TLE984xQX

Microcontroller with LIN and Power Switches for Automotive Applications

This document lists the deviations of the TLE984xQX “Microcontroller with LIN and Power Switches for Automotive Applications”.

Figure 1 lowside clamping, normal case (Vs = 13.5V, relay, 160 Ohm (nom.))

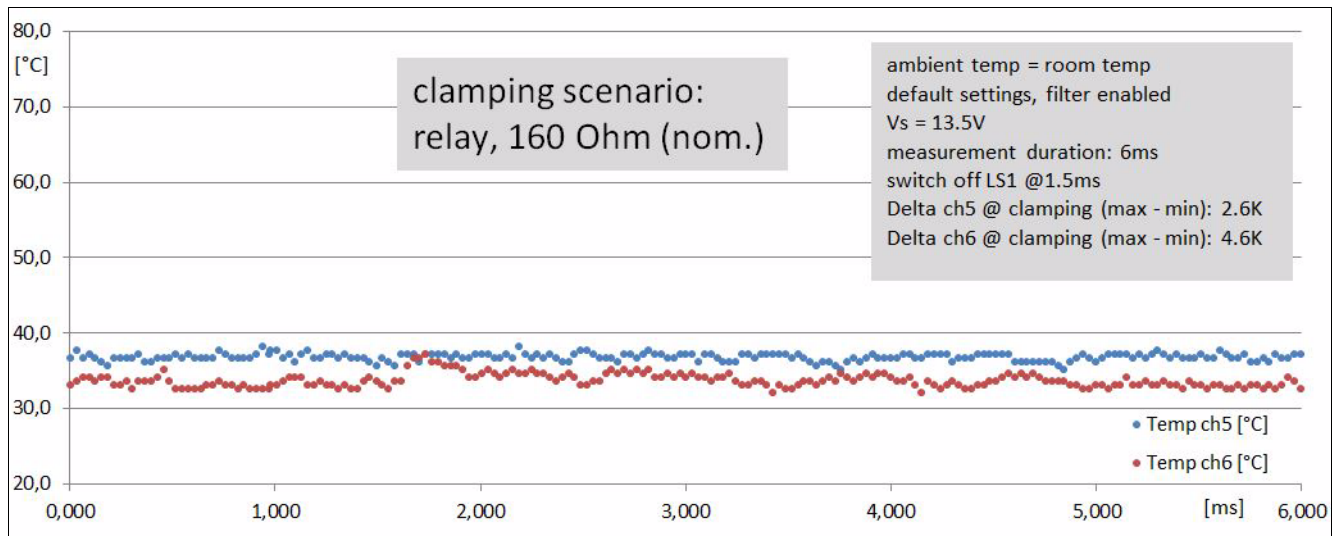
Figure 1 shows the temperature effect of LS1 clamping in normal operating condition. The local heating effect caused by the clamping of the lowside can be seen in channel 6 instead of the expected channel 5, as the channels appear swapped. The short temperature increase caused by the clamping is $< 5K$ Kelvin.

Figure 2 lowside clamping, worst case (Vs maximized to reach 2mJ clamping energy, relay, 160 Ohm (nom.))

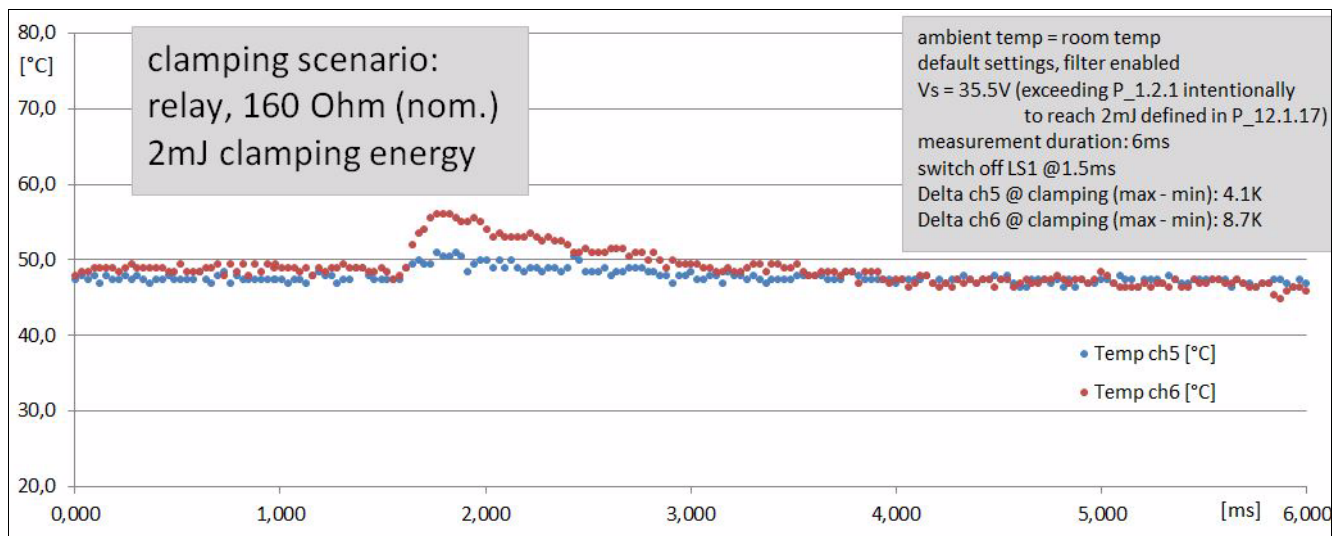
Figure 2 shows the temperature effect of LS1 clamping at worst case conditions. Vs has been selected intentionally that high to reach 2mJ clamping energy as specified in P_12.1.17. Again, the short temperature increase can be seen in channel 6 instead of channel 5, and is <9Kelvin.

Figure 3 lowside current, normal case ($V_s = 13.5V$, relay, 160 Ohm (nom.))

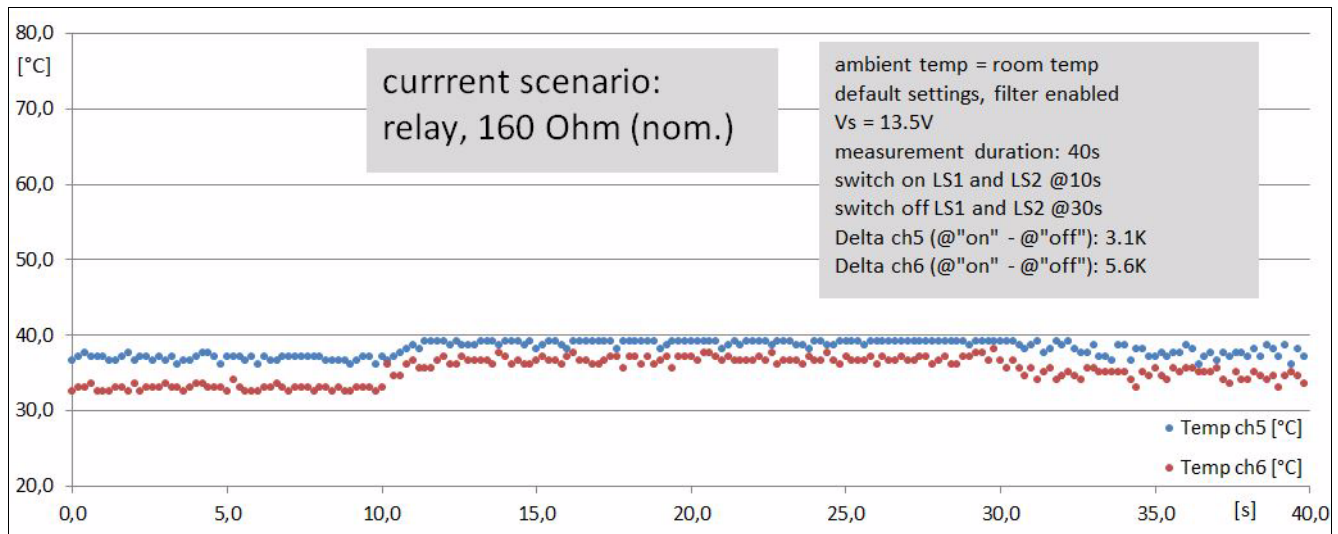
Figure 3 shows the temperature effect of a relay current in normal operating condition. The local heating is <6Kelvin.

Figure 4 Updated application information

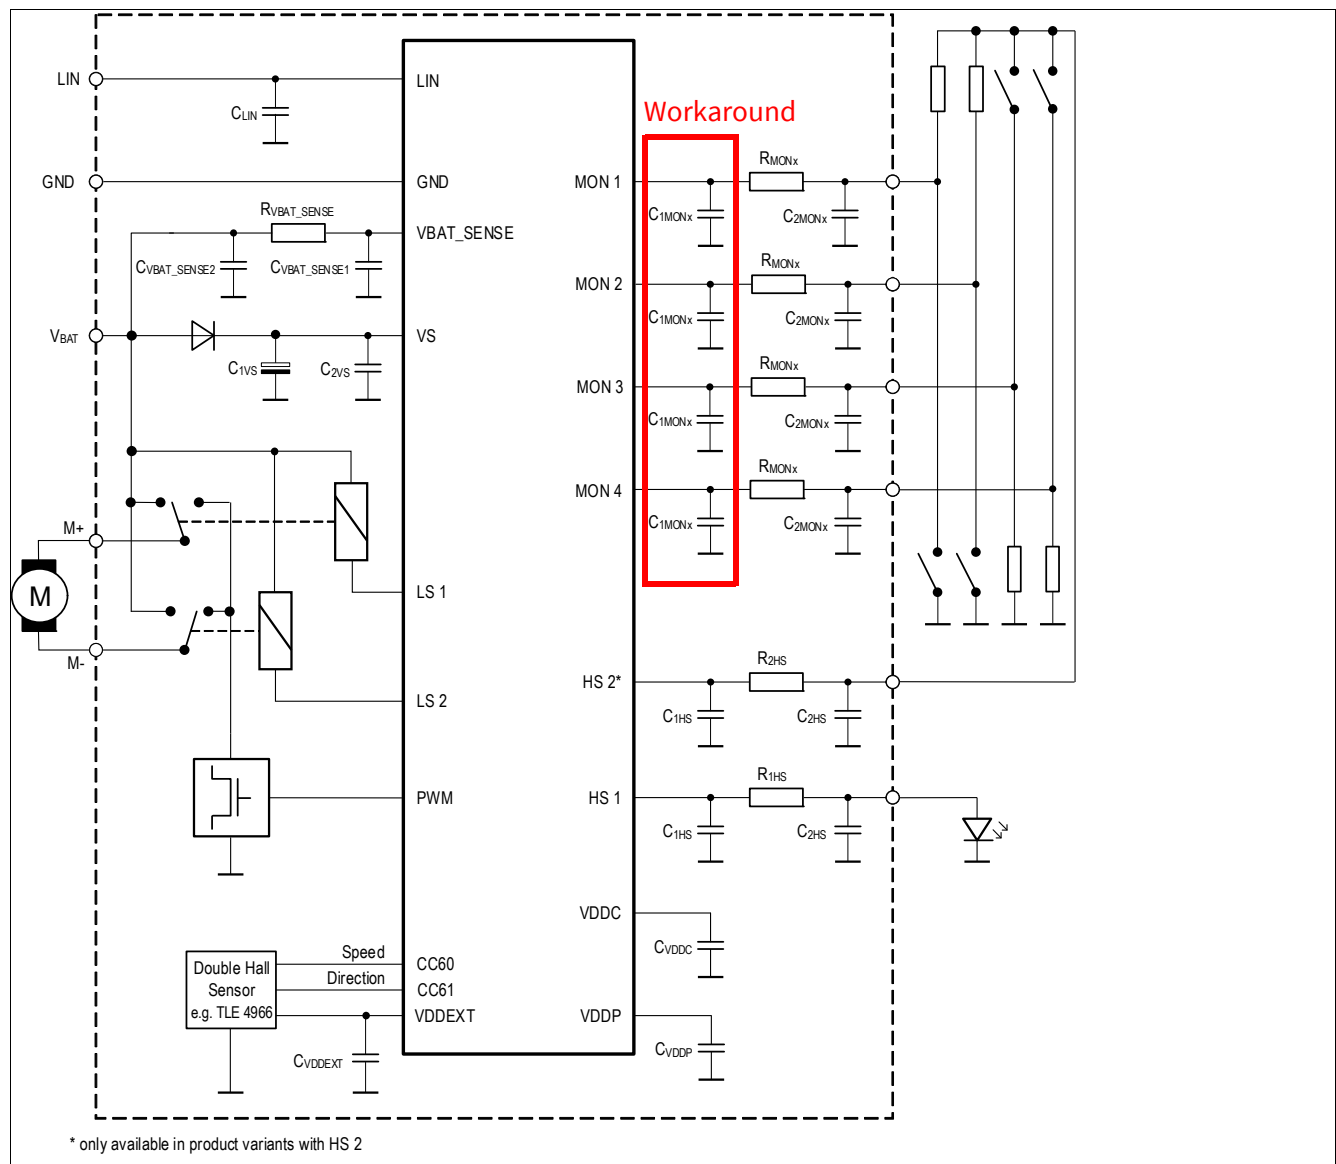
Fast transients on the enabled ADC1 HV-Channel could activate the ADC sampling switch, which will lead to a load of 10 k Ω (+/- 20%) on the causing channel.

The activation will increase the input current ($> 100 \mu\text{A}$ @ $V_S 13.5 \text{ V}$) on corresponding MONx pin. This increased current can cause a voltage drop via the external resistor. Depending on the size of the resistor the voltage drop can be so high, that a wrong low signal on the MONx will be detected.

To achive robustness against ISO 7637-3 pulses, the recommended R-C filter from the “Reference Data Sheet” is sufficient. To increase the robustness an additional 10nF capacitor ($C_{1\text{MONx}}$) is recommended. This will lead to a C-R-C filter. See [Figure 4](#).
